MEMORANDUM

To: Development Review Board
From: Mary O'Neil, Associate Planner *MO*
Date: April 19, 2011
RE: 145 Lakeview Terrace, ZP 11-0012CA / AP

Request: Extend rear dormer along southern roofline for 15 ½ feet of original roofline; window and canopy changes.

SOUTH ELEVATION

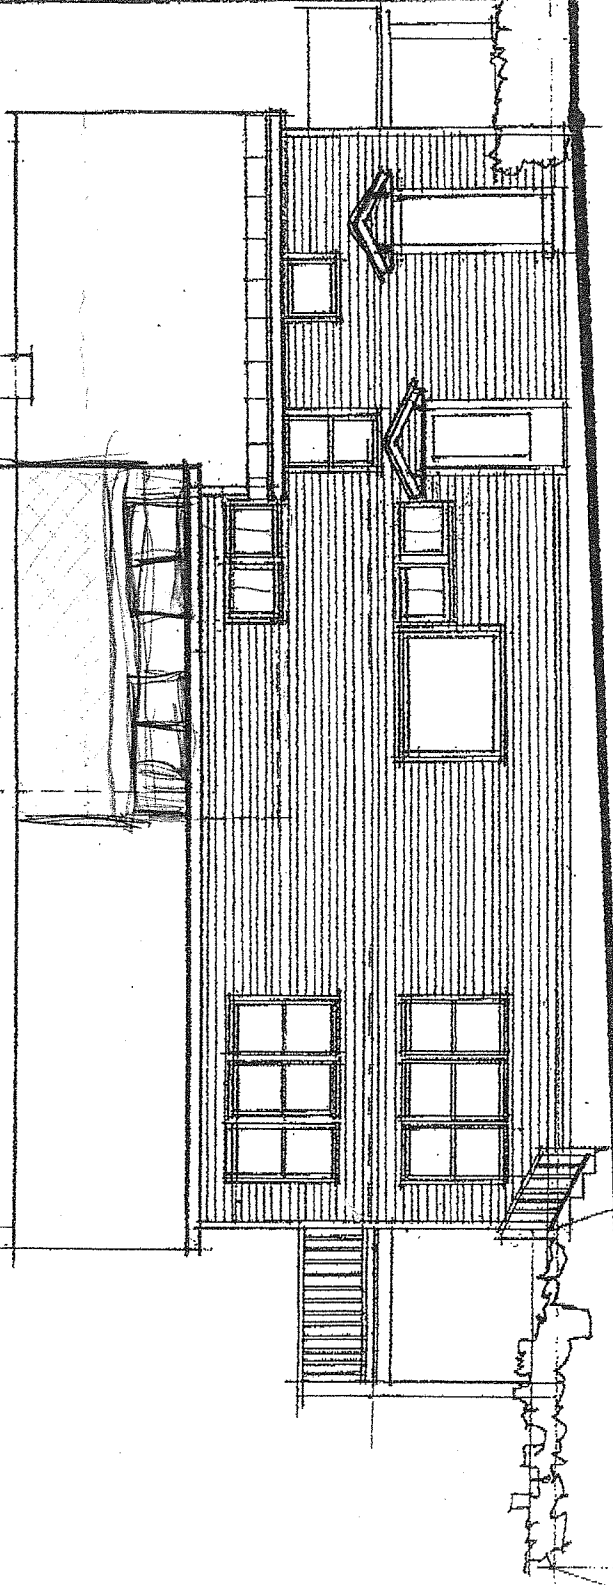
The primary façade of the building is not proposed for development; however the application proposes the replacement of canopies at secondary entrances on the south elevation. While hipped roof porticos are existing, the application proposes gable roof canopies in an effort to replicate the primary entrance. The Vt. Designation description describes the original canopy configuration as it exists today; their retention would assure continuation of an existing feature. See Sec. 5.4.8 (3.) below. **Adverse finding.**

The hipped roof porch canopies, as noted in the 1993 survey report, are a characteristic of the structure; their retention considered. **Adverse finding.**

The project design is not to remedy building material failure, but to facilitate internal use. However, if porch canopy replacement is based on deterioration, then reasonable consideration should be given to replacement that matches the existing canopies. **Adverse finding.**

EXHIBIT B

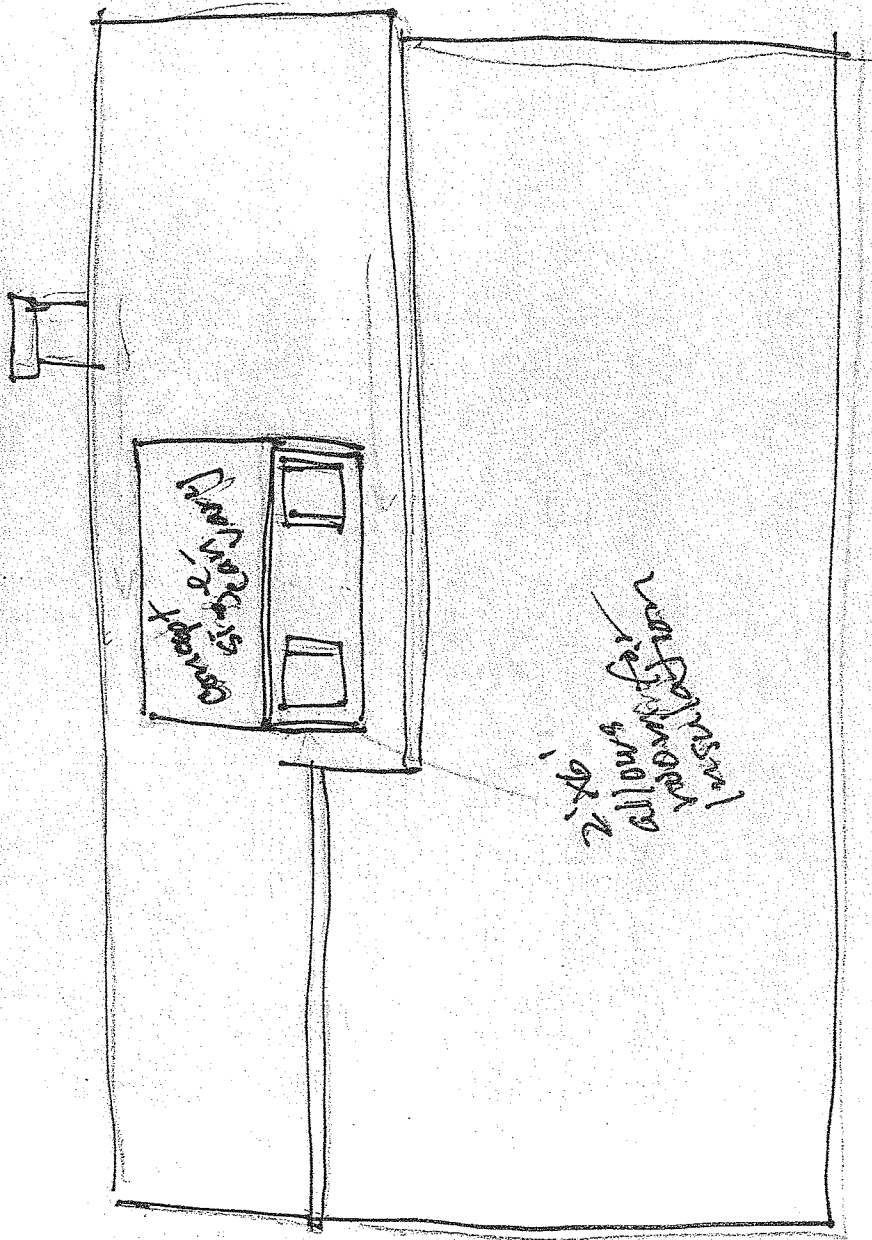
Following up on yesterday's discussion attached is a rough sketch of what we believe to be the DAB recommendation and that it would be acceptable to staff. If this is a design that you would be willing to implement you will need to have an elevation done and submitted to staff for review.

concept as per suggestion —

EXHIBIT C

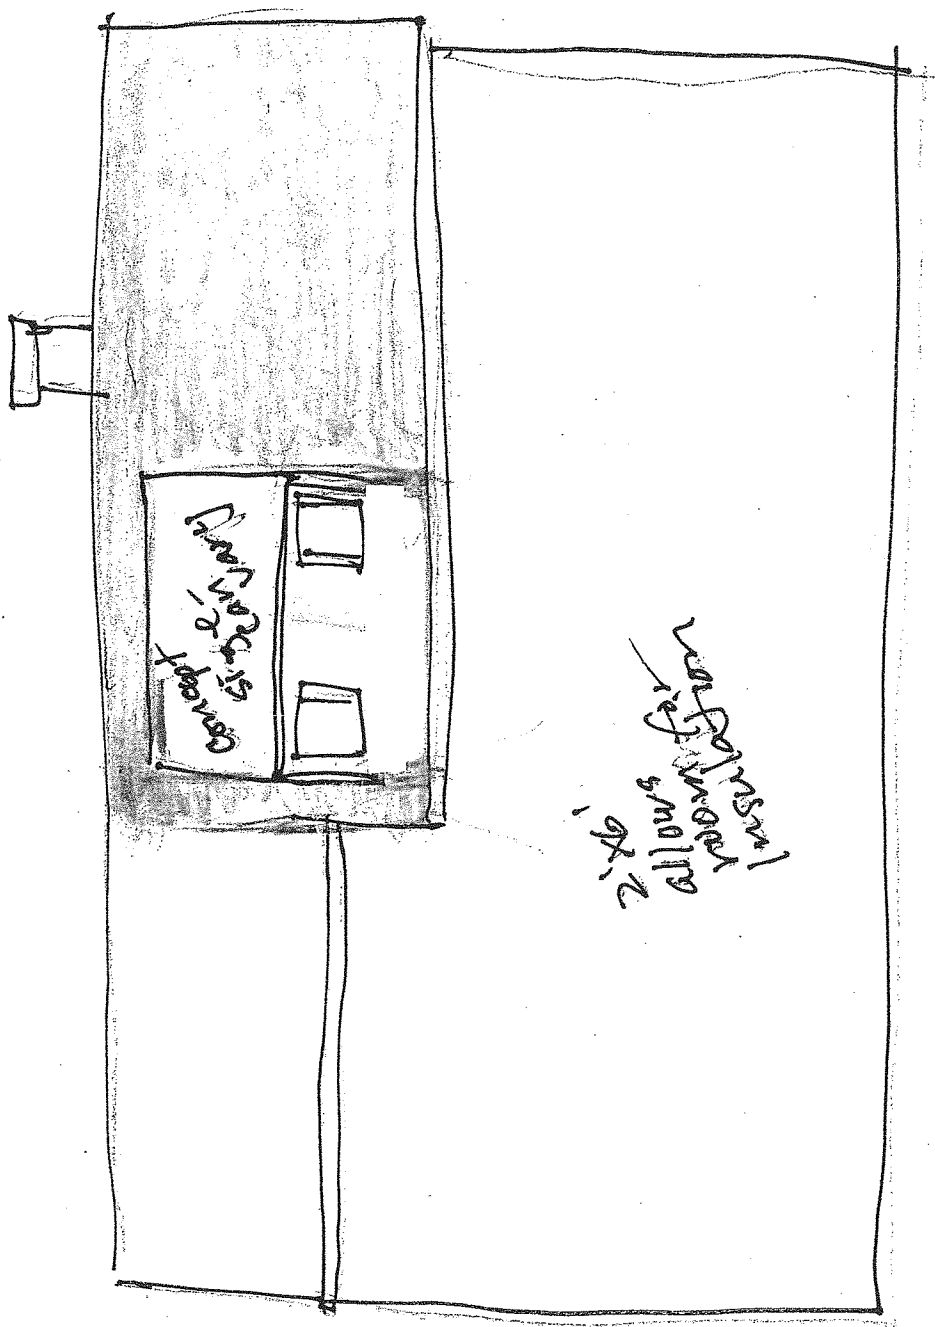
only kind of
building in
area

We have decided not to amend our plans as you last recommended earlier today. Your last proposal called for a 1 foot "gully" between the rear addition roofline and proposed dormer addition. This design is highly energy and space inefficient and I believe would create a dangerous condition where ice would form in this narrow, shaded gully. When it fell from its steep sloped roof, it would be onto a driveway where someone could get hurt or property (such as a parked car) damaged.

ALAN BLECKE DORMEX ADDITION

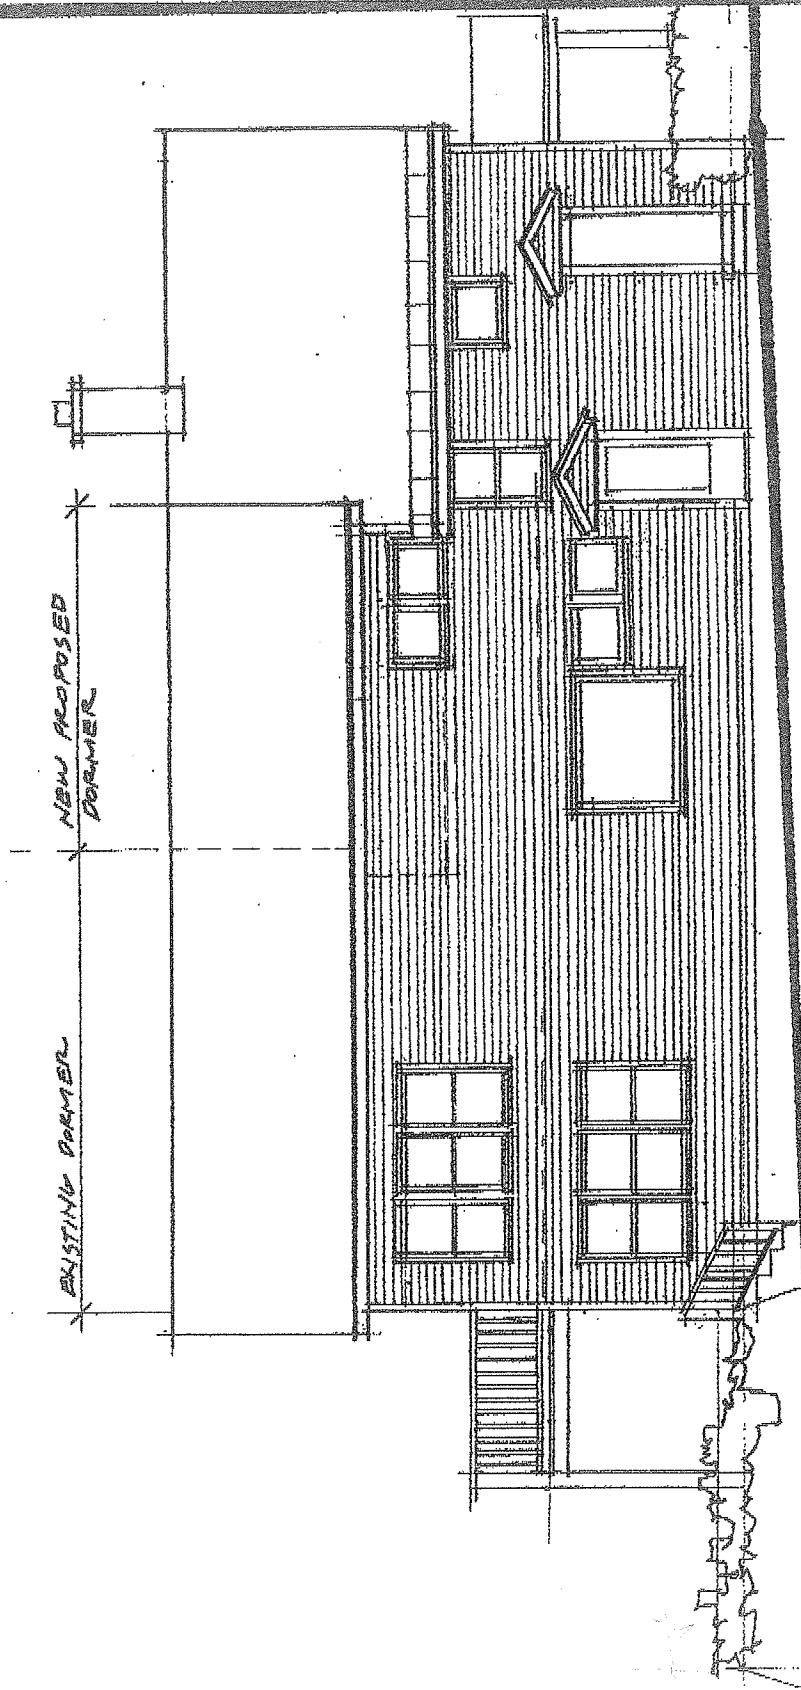
While the proposed "continuation" of the rear dormer will not exceed the height of the existing rear dormer, it does eliminate the original roofline and blurs the ability to discern the original house massing, height, and scale. Visually, the rear addition becomes continuous and dominant; eliminating the opportunity to view the original house massing and supersedes the scale, and thus the importance of the original structure. **Adverse finding.**

As noted, extending the newer rear dormer onto the original roofline eliminates the clear distinction between old and new; removing the original eave-line and roof pitch characteristic of the older home. Additionally, the application proposes to forfeit original traditional roofing material and replaced with asphalt shingle. Both the roof pitch and material will differ and make it difficult to discern the older portion of the residence from the newer. **Adverse finding.**

The proposed dormer extension will effectively eliminate the distinction between the original structure and the new addition. It will no longer be possible to discern old from new. Original massing and roof characteristics will be irreversibly altered. The alteration of the roofline so as to obscure the original house massing conflicts with this standard. **Adverse finding.**

The continuation of the rear dormer (which is actually a two-story roof height) will significantly eliminate the existing eaves-line and thus alter the apparent massing of the original house. **Adverse finding.**
